**Subject:** Preliminary Plat with lot width and lot area variances, Rod Helm on behalf of Tom and Gretchen Shanight, 5612 Tracy Avenue. Resolution No. 2013-65

**RESOLUTION NO. 2013-65  
APPROVING A PRELIMINARY PLAT WITH LOT WIDTH AND LOT AREA VARIANCES  
AT 5612 TRACY AVENUE**

## PLANNING COMMISSION STAFF REPORT

ALTERNATE GRADING, DRAINAGE, UTILITY AND TREE PLAN  
**Tom & Gretchen Shanight**  
 5612 Tracy Ave.  
 Eden, MN 55436

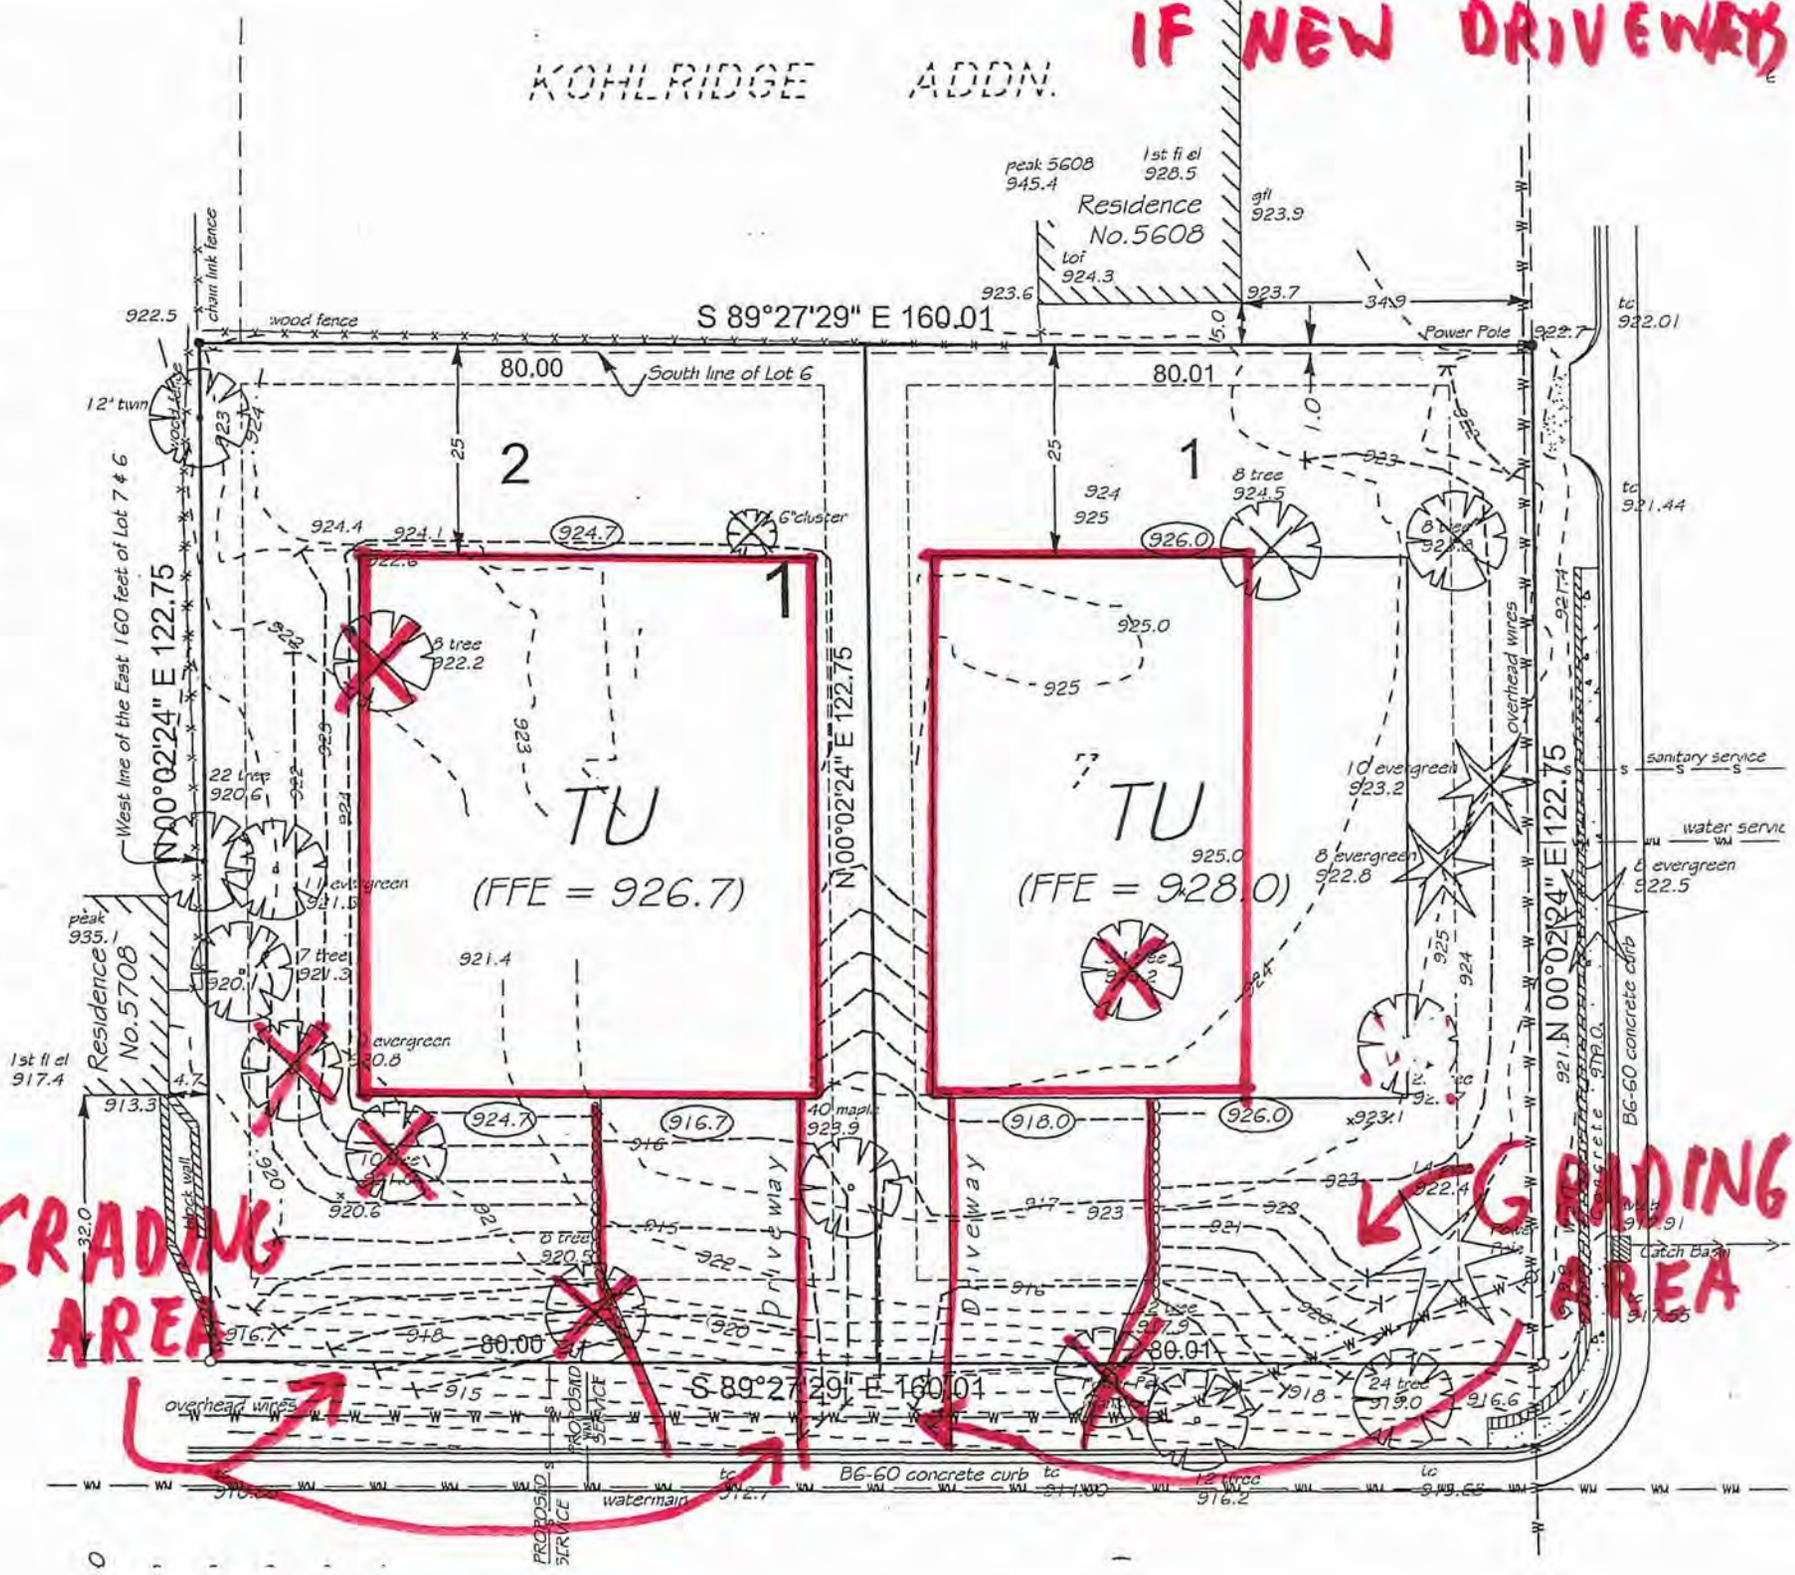
The grading plan shows the buildable area for Lot 1 with a 15 foot setback off of Tracy Avenue. (See page A15.) The required setback is 35 feet, to match the setback of the home to the north. If this subdivision is approved, it would not approve a building pad for a 15-foot setback. However, as indicated on page A15, there still would be adequate building area for a new home. There would be a building pad of 39 feet by 65 feet or 2,535 square feet.
